Item 3 - Correspondence

Re: 5500 Wisconsin Ave. Development Sketch Plan

RE: OPPOSITION TO 5500 WISCONSIN AVE. SKETCH PLAN

5500 WISCONSIN AVE

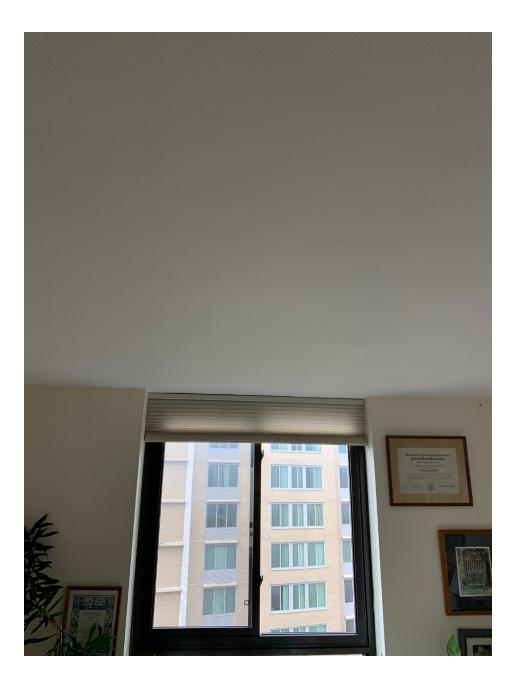
This photo was taken by me on November 12, 2021. It is the view from a bedroom window in 4620 North Park Avenue condominiums, 11th floor, looking directly across North Park Avenue into the former Irene at 4701 Willard Avenue (now called Willard Towers). The two buildings are on opposite sides of North Park Avenue and confront each other. The distance between the buildings was 100 ft as measured physically by a measuring tape. The photo was taken from 10 feet into the bedroom. Therefore, the photo of Willard Towers is at a distance of 110 feet. The photo was taken on my cell phone at the default setting, i.e., no enlargement or other alteration. The staff report for the 5500 Wisconsin project, on page 17, notes the apartments in the proposed building would be 80 feet from the confronting Highland House apartment building for the first 6 floors, and 110 feet for the next 12 floors.

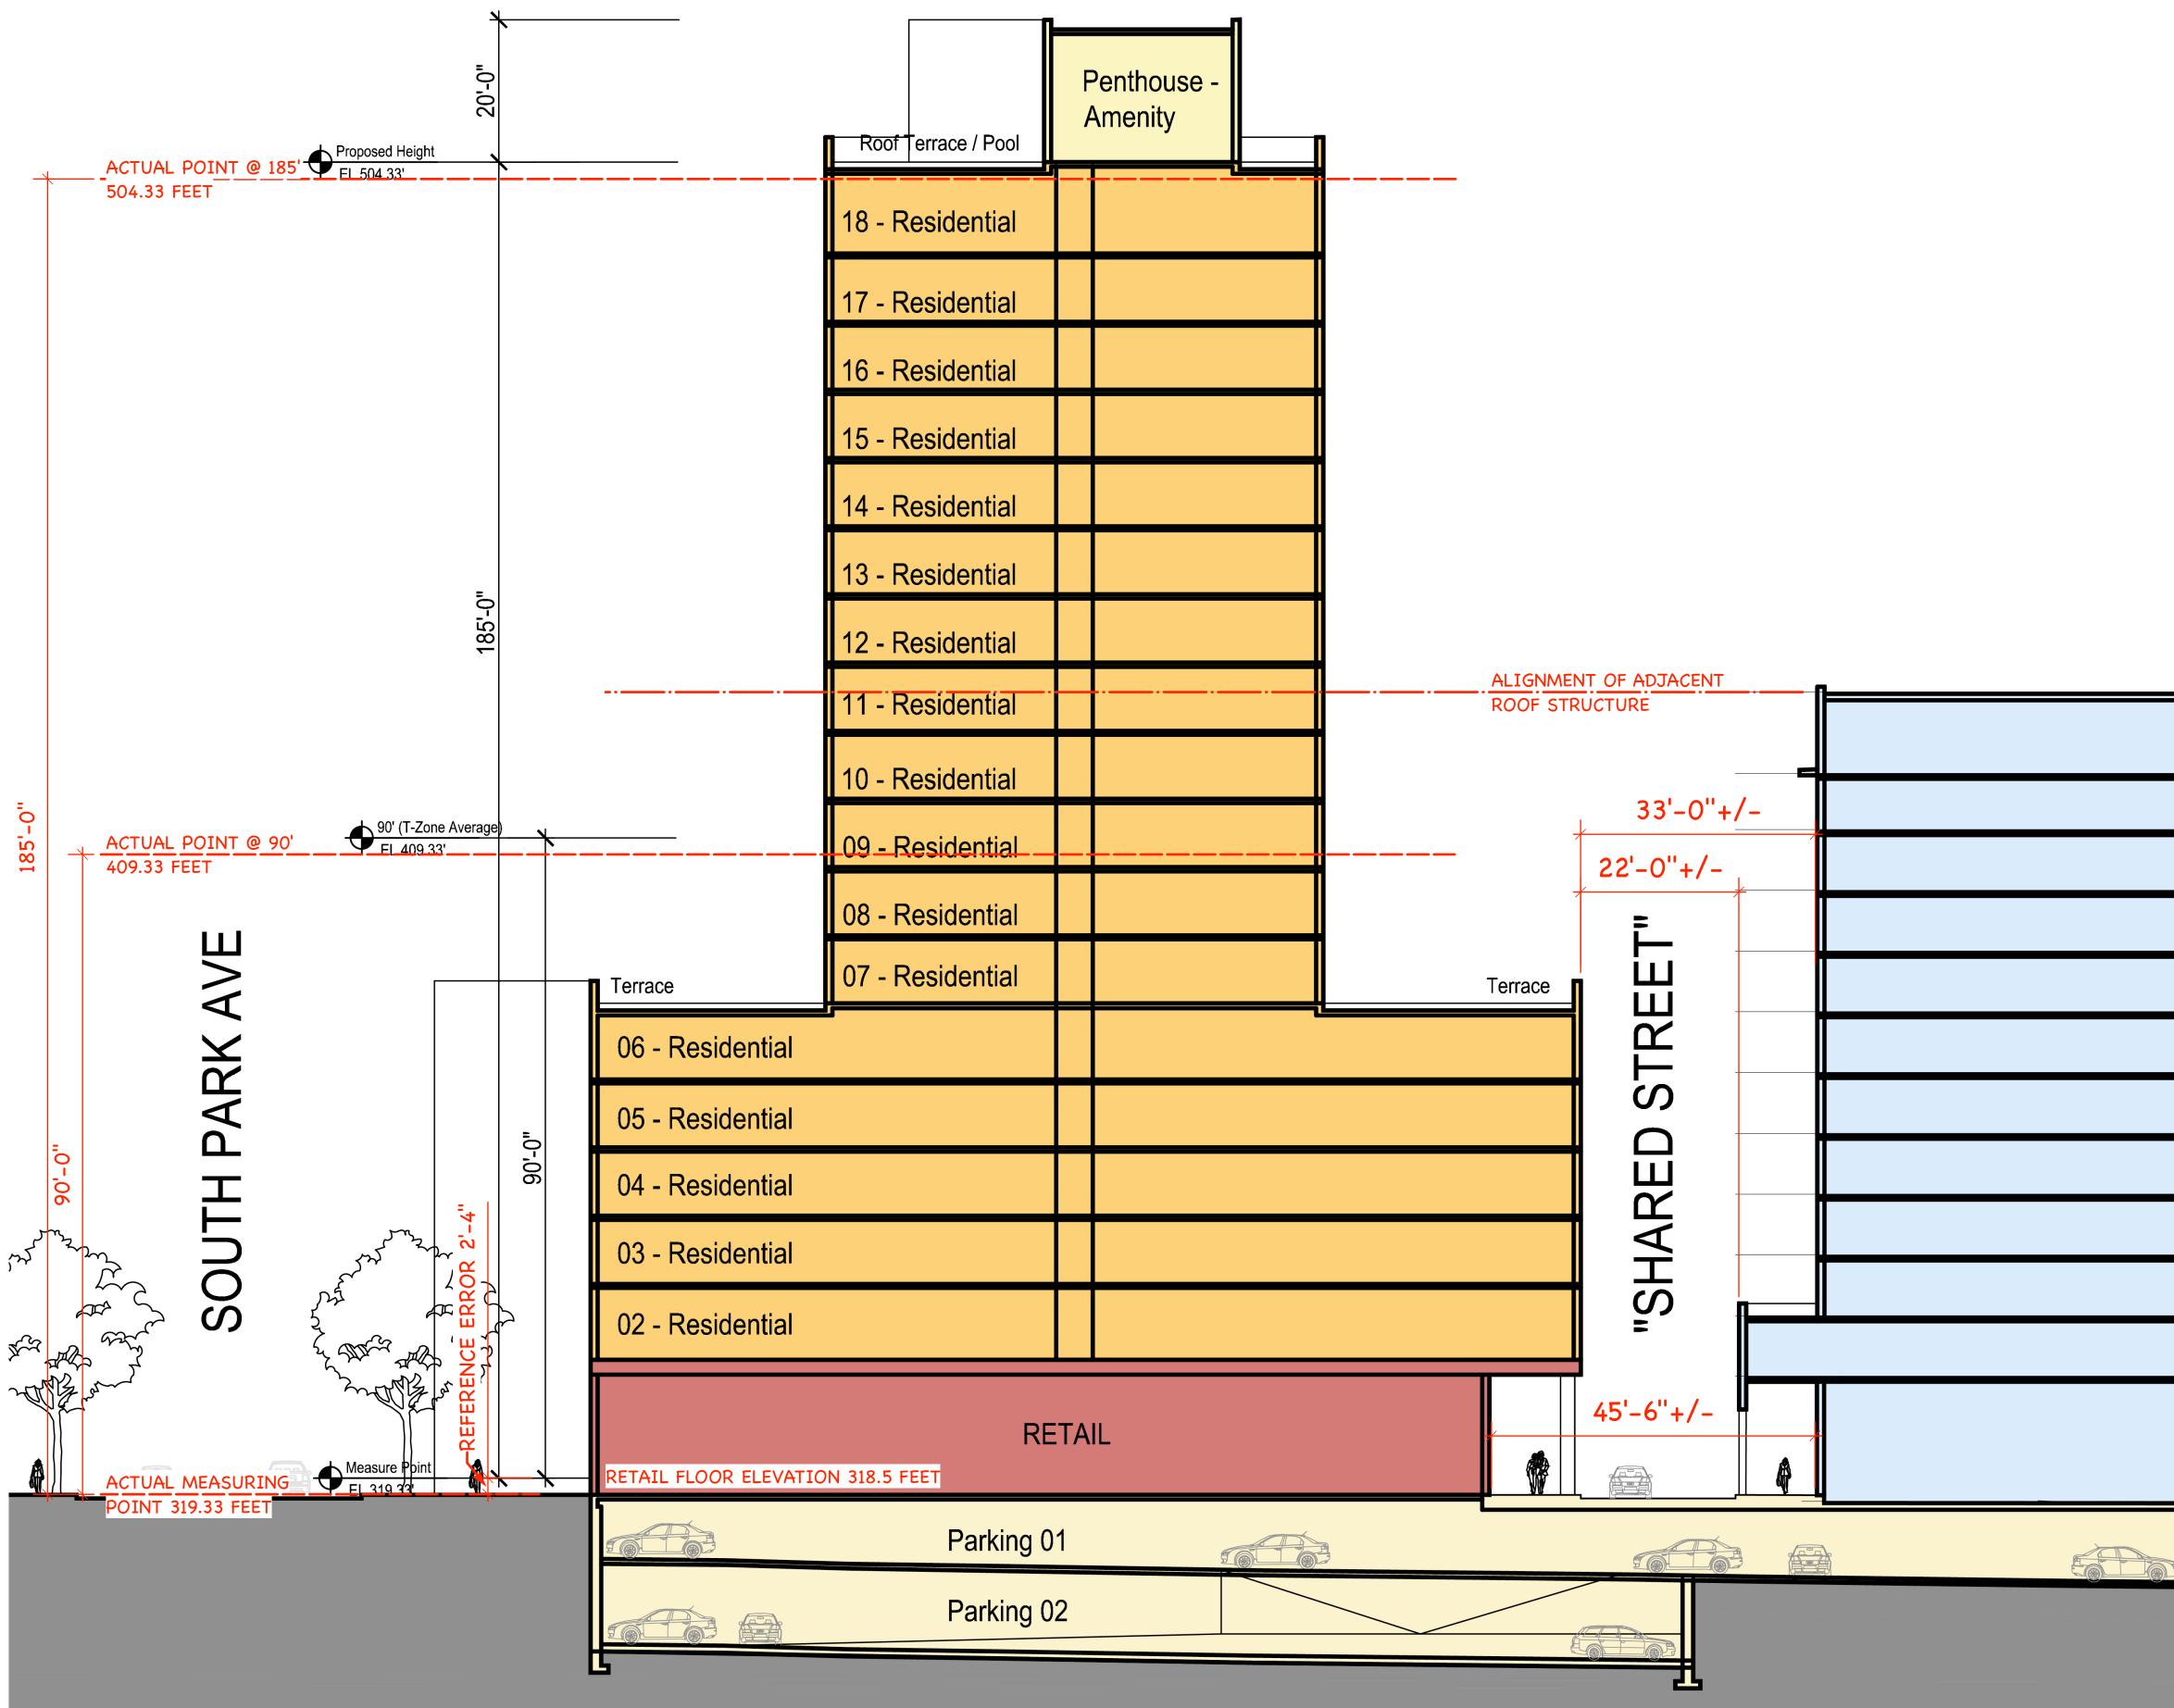
Please enter the attached document in the record of the above referenced hearing. I will be using this as part of my testimony .
